Government Departments' General Comments

Proposed Temporary Shop and Services for a Period of 3 Years and Associated
Filling of Land
(A/YL-SK/392)

A/YL-SK/392

Lot 443 (Part) in D.D. 112 and Adjoining Government Land, nr end of Nam Hing Road, Shek Kong

PROPOSED DRAINAGE PLAN

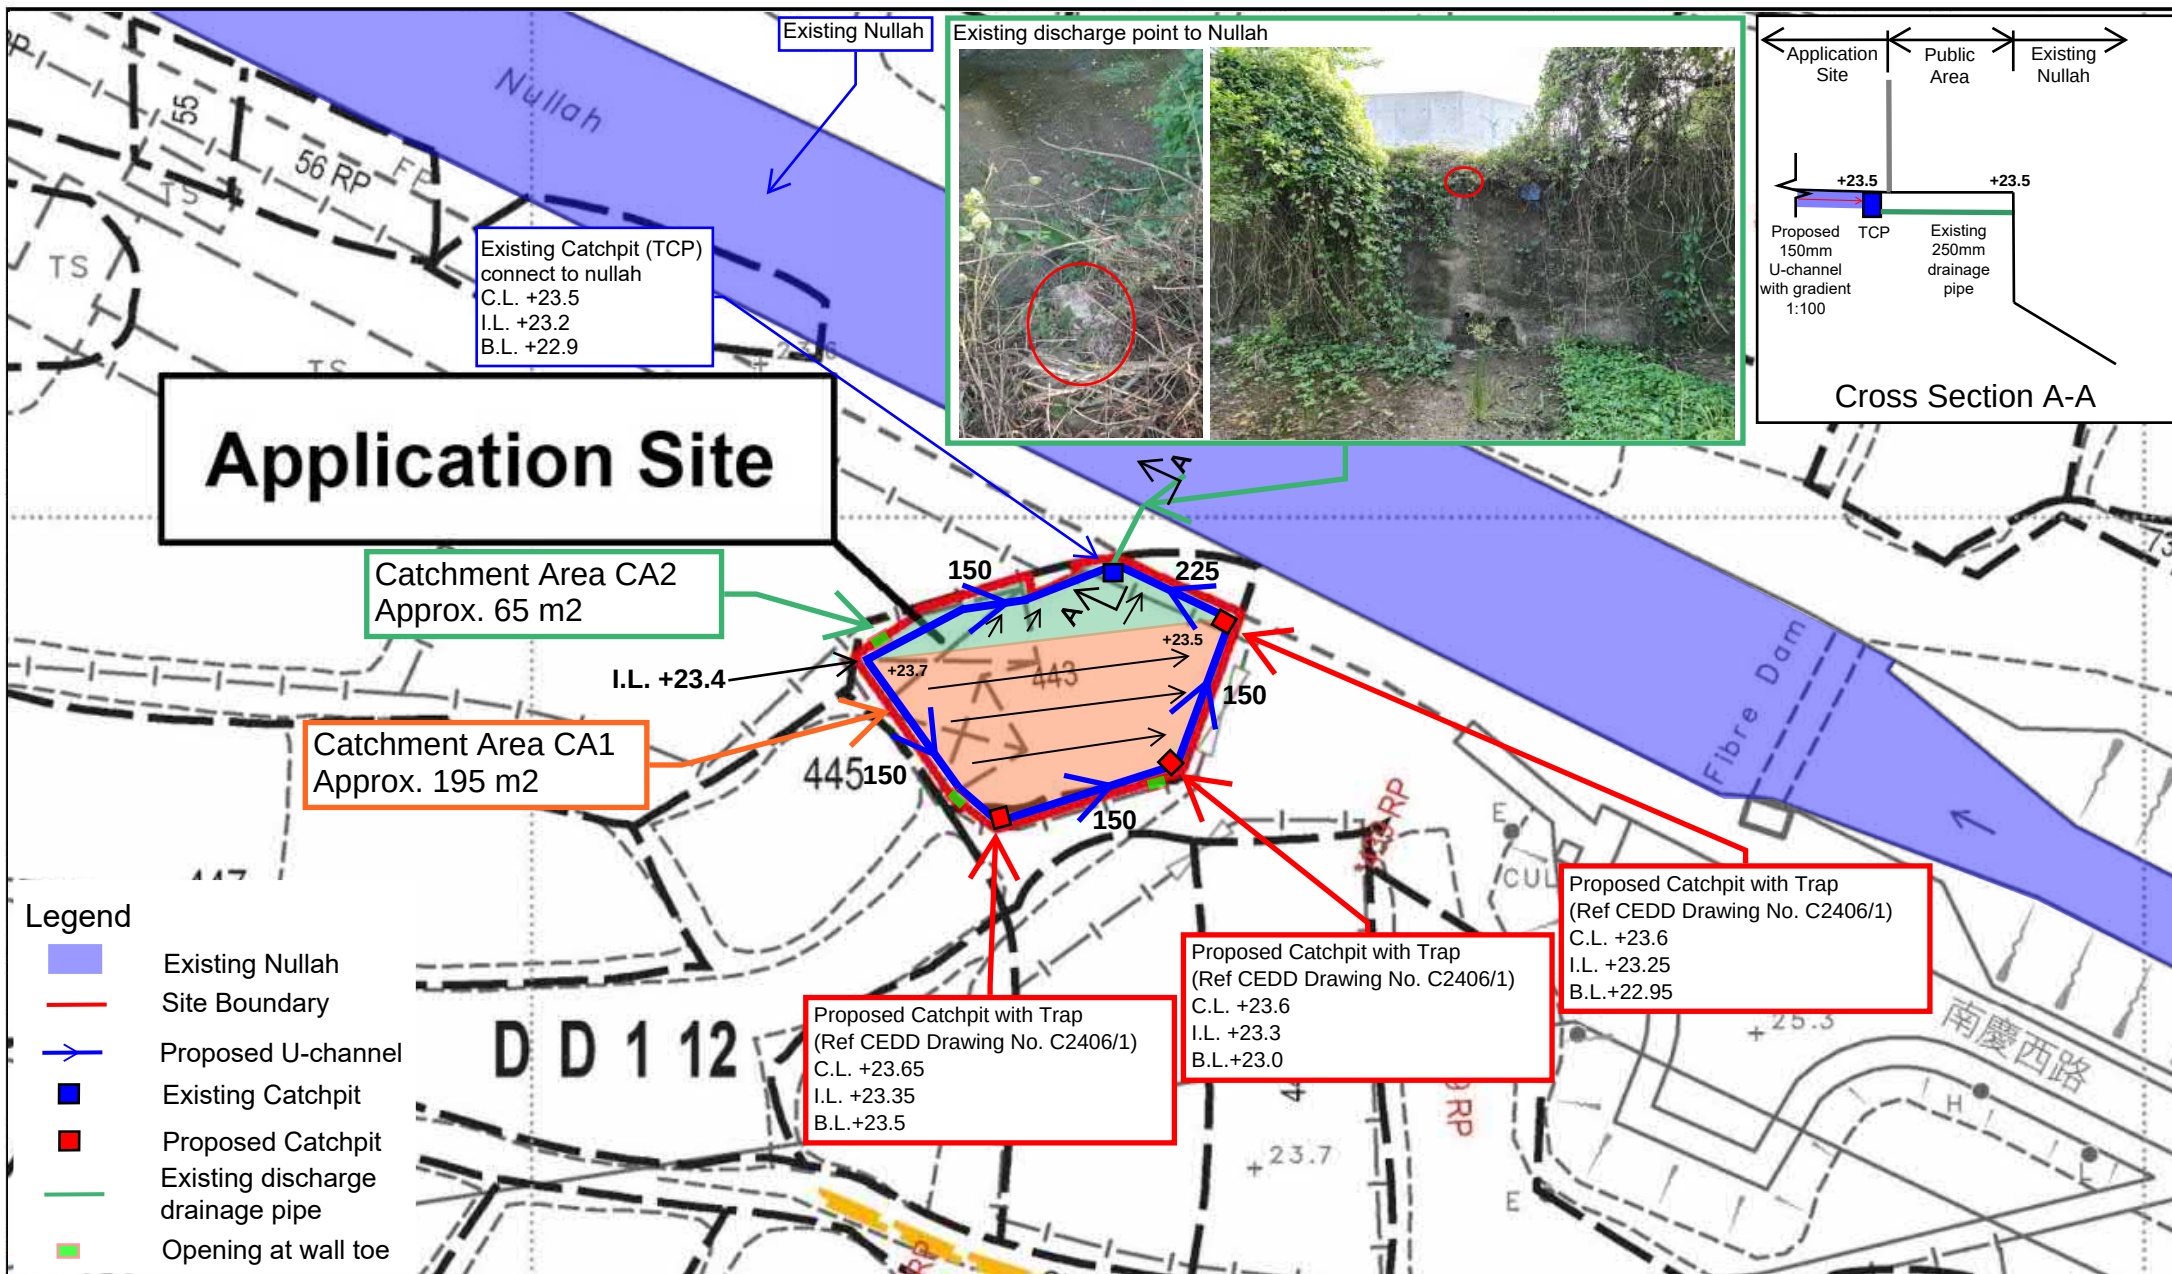
3. The submitted drainage plan indicates that only one u-channel at the north eastern side of the site will be provided. Please advise how the overland flow from the above area of the site could be properly intercepted and discharged. In general, peripheral surface channels shall be provided along the site boundary to collect the surface runoff accrued on the application site and to intercept the overland flow from the adjacent lands.	Peripheral surface channels is now proposed to encounter the surface runoff and intercept the overland flow from the adjacent lands. Layout plan updated accordingly in Appendix C

and catchpit in the drainage plan.	are now included in Appendix C.
6. Please demonstrate the proposed site formation works will not affect the overland flow from the adjacent lands.	Consider the level application site is higher than the adjacent road, lands and lots, the site formation works would not affect the overland flow, sections showing the application site and adjacent lands is provided in Appendix C.

9. Adequate opening should be provided at boundary walls to intercept the existing overland flow passing through the site.	Adequate opening will be provided at boundary walls, location of the openings is now marked in Appendix C layout plan.
